TASK 4—FINAL TECHNICAL PEER REVIEW OF WATER BUDGET MODELING FOR MINIMUM RECOMMENDED LEVELS: LAKES ALTO AND SANTA FE, FLORIDA

Suwannee River Water Management District

JUNE 29, 2018

Figure 1—Atlantic Multidecadal Oscillation

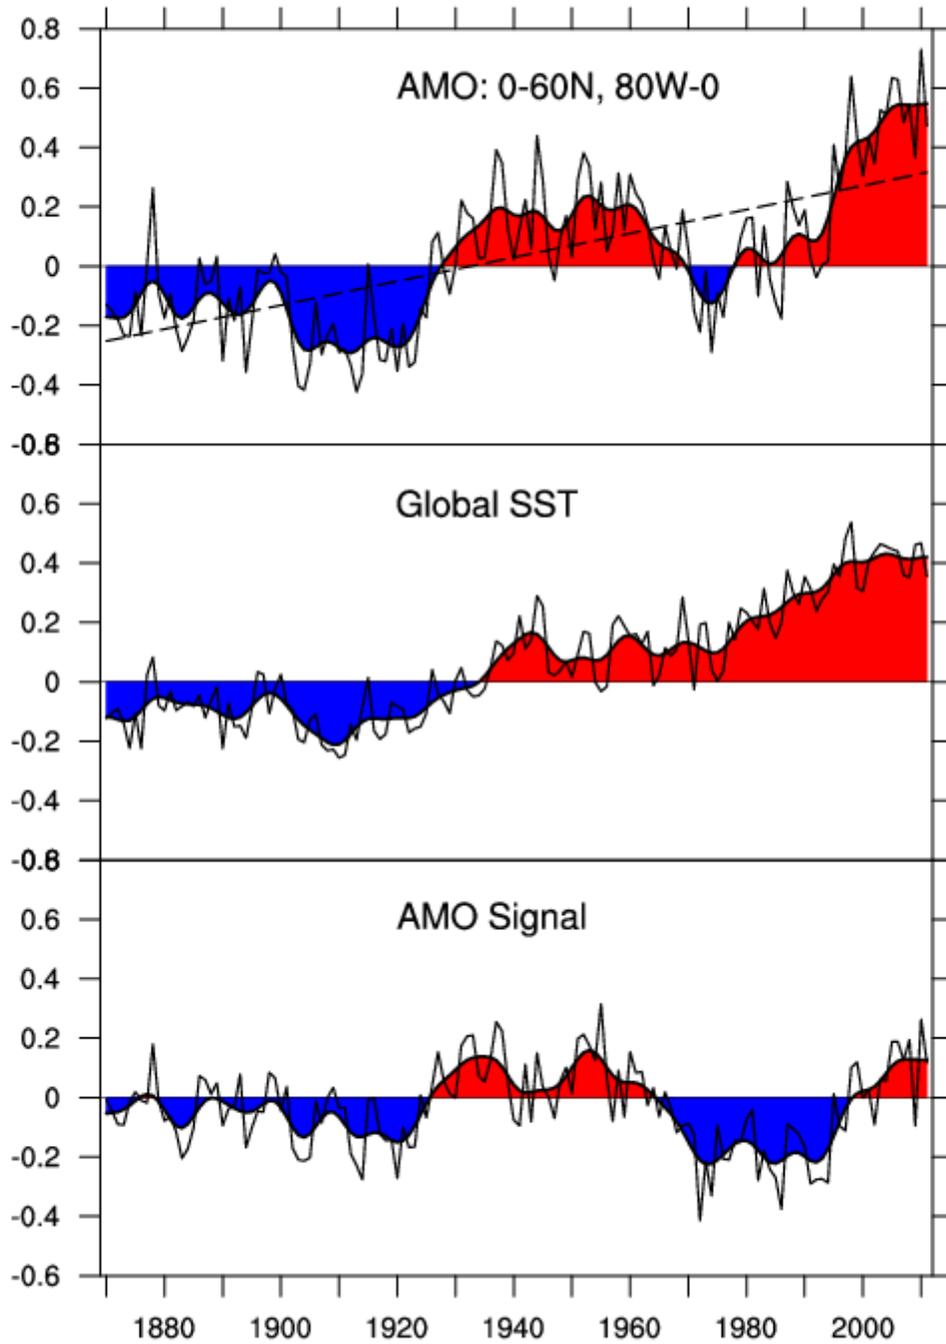
Atlantic Multidecadal Oscillation (AMO) is regarded as indicative of the cyclical patterns of south and central Florida rainfall. AMO has warm and cool phases, the warm phase indicating generally higher rainfall and the cool phase lower rainfall (Enfield et al. 2001). The graphic presented in Figure 1 shows the historic phases of the AMO. AMO represents 10-year moving averages of North Atlantic Sea Surface Temperature. Thus, the last point on the graph is the midpoint of the current decade, 2011. Applicability of these concepts to the SRWMD lakes was discussed at length by Dr. Rao in the DSV report, *Technical Peer Review of Minimum Recommended Levels: Lake Butler, Florida*, January 23, 2017. Dr. Rao recommends performing the evaluations suggested in the preceding report with Lakes Alto and Santa Fe rainfall data.
